Glenorchy Planning Authority Meeting Monday, 8 December 2025

**5 PROPOSED USE AND DEVELOPMENT – SIX (6)
MULTIPLE DWELLINGS – LOT 1 ALLUNGA ROAD,
CHIGWELL**

Application No.:	PLN-25-093
Applicant:	Field Labs
Owner:	Homes Tasmania (Hobart)
Zone:	General Residential Zone
Use Class	Residential
Application Status:	Discretionary
Discretions:	8.4.2 P1 Setbacks and building envelopes for all dwellings 8.4.2 P3 Setbacks and building envelopes for all dwellings 8.4.3 P2 Site coverage and private open space for all dwellings 8.4.5 P1 Width of openings for garages and carports for all dwellings 8.4.8 P1 Waste storage for multiple dwellings C2.5.1 P1.1 and P1.2 Car parking numbers C3.5.1 P1 Traffic generation at a vehicle crossing, level crossing or new junction C7.6.1 P1.1 Buildings and works within a waterway and coastal protection area or a future coastal refugia area (The proposal meets all other applicable standards as demonstrated in the attached appendices)

Figure 5: Site plan with setback margin - Field Labs

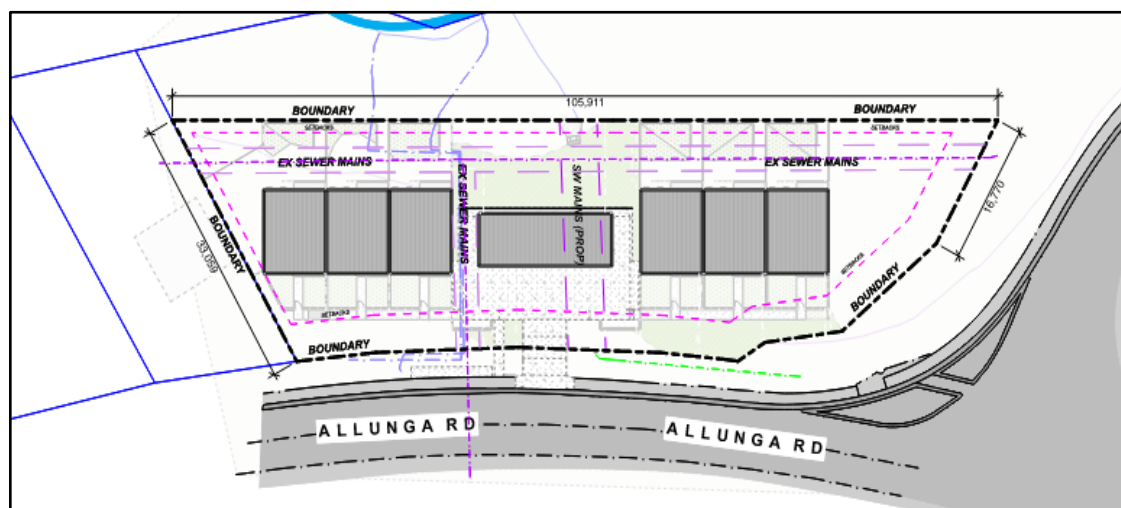
There would be also two bin enclosures that only have frontage setbacks of 2.235m and 2.656m. These have a 5.2m long, 1.1m high street front façade. The bin enclosures are assessed under the standard for waste storage that includes consideration of the frontage setback as the enclosure would meet the frontage fence exemption and is therefore not required to be assessed as a building envelope discretion.

The layout of the site shows the front enclosures stepping over the pink line which denotes the 4.5m frontage setback margin in Figure 5.

The plan shows that the width of the nature strip widens adjacent to the front boundary outside Unit 5 and 6. This gives a reasonably consistent setback from the road alignment for all dwellings. Therefore, it is considered that the proposed frontage setback would be acceptable as it would be compatible with the streetscape and is also reasonable due to the irregular front boundary.

Figure 6: Natural Assets Code waterway and coastal protection overlay (theList) and proposal plan superimposed

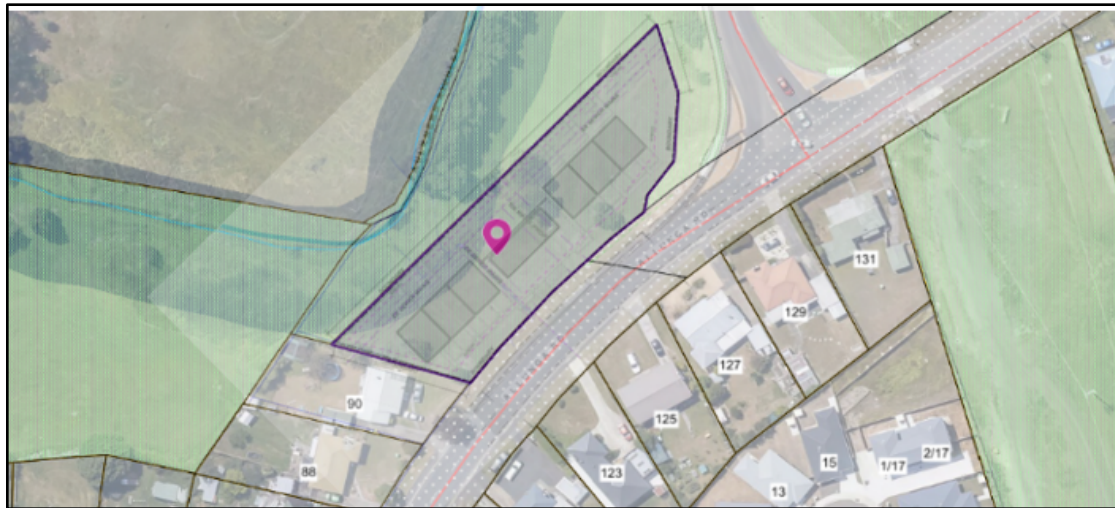
The proposed buildings slightly encroach on the waterway overlay at the rear, as shown in Figure 6. The title to the property does not have a building area. This means that the performance criteria apply.

The performance criteria seek to minimise any adverse impacts on the waterway. The proposed buildings are a significant distance from the streambed, approximately 18m. The area within the overlay as well as the adjacent area have been previously modified and are vegetated with grass. Building works will need to be managed in accordance with an Erosion and Sediment Control Plan. There would be minimal impact caused by way of erosion or earthworks. It is not expected that there would be any obstruction to the natural flow, fish passage or loss of littoral vegetation.

Figure 1 – 10B Rev D by Field Labs

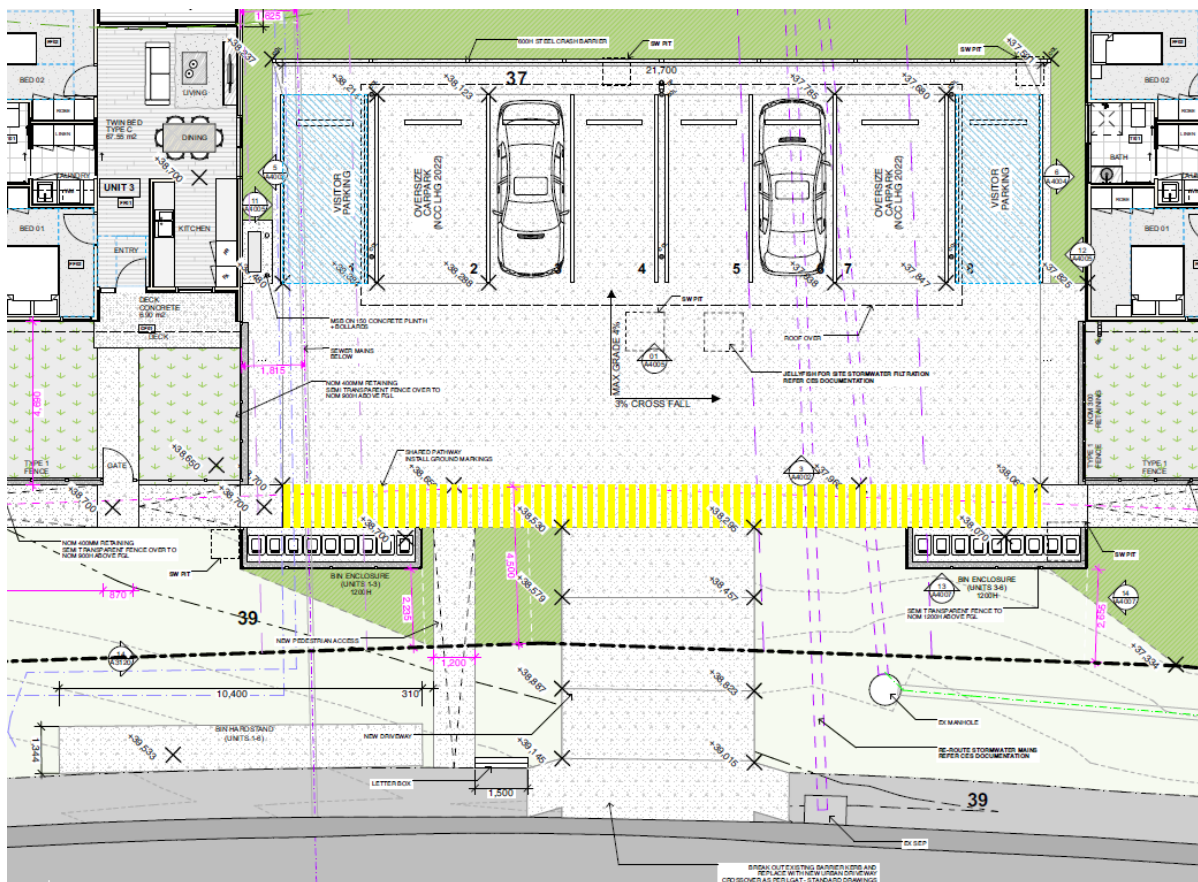
The development is proposing to have 8 parking spaces, consisting of one car park per two-bedroom units and two visitor parking spaces. The planning scheme under C2.5.1 requires 14 spaces, of which two parking spaces per dwelling and two visitor parking spaces. As the parking does not meet the requirement of the planning scheme, the performance criteria was addressed in the TIA.

A pedestrian path is proposed from the site to Council's footpath, to allow pedestrians to safely exit the site and to place their waste bins on the footpath. The footpath where bins will be placed will be widened to allow pedestrians to pass. A pedestrian path will also be provided along the frontage of the site, as shown in Figure 1 below, meeting the acceptable solution for C2.6.5 Pedestrian Access.

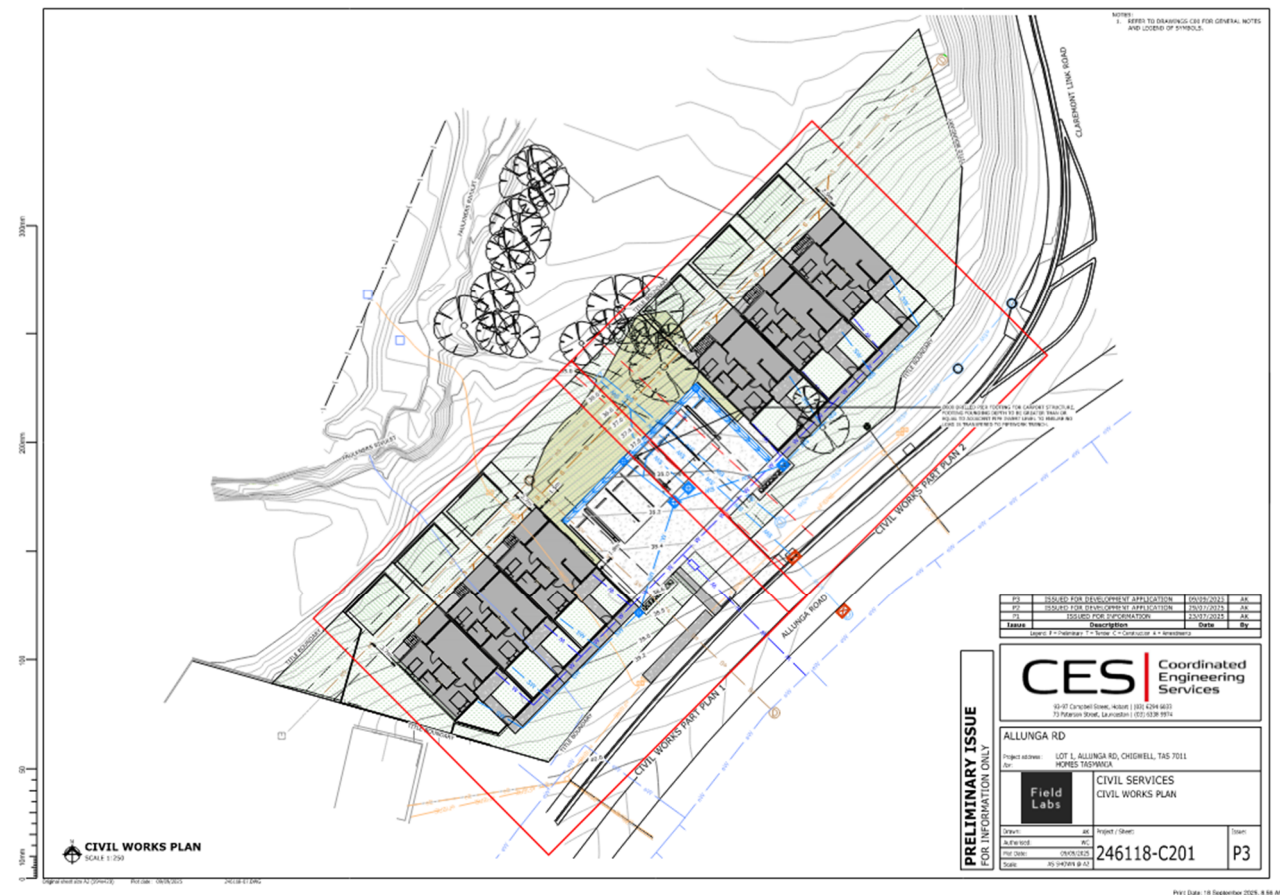
The six-unit development and car parking arrangement are a functional design with no concerns from council regarding overall design, drainage and manoeuvring on site. No disabled parking is provided.

The development has a shortfall in parking of 6 spaces. This shortfall in traffic would force on street parking. This is a concern for council given the nature and traffic on Allunga Rd and the developments proximity to Claremont Link Road.

Management of the property owners by restricting residents to 1 car park per dwelling is assured by Home Tasmania and confirmed that this will be manageable was assured to council by Peter Hubble.
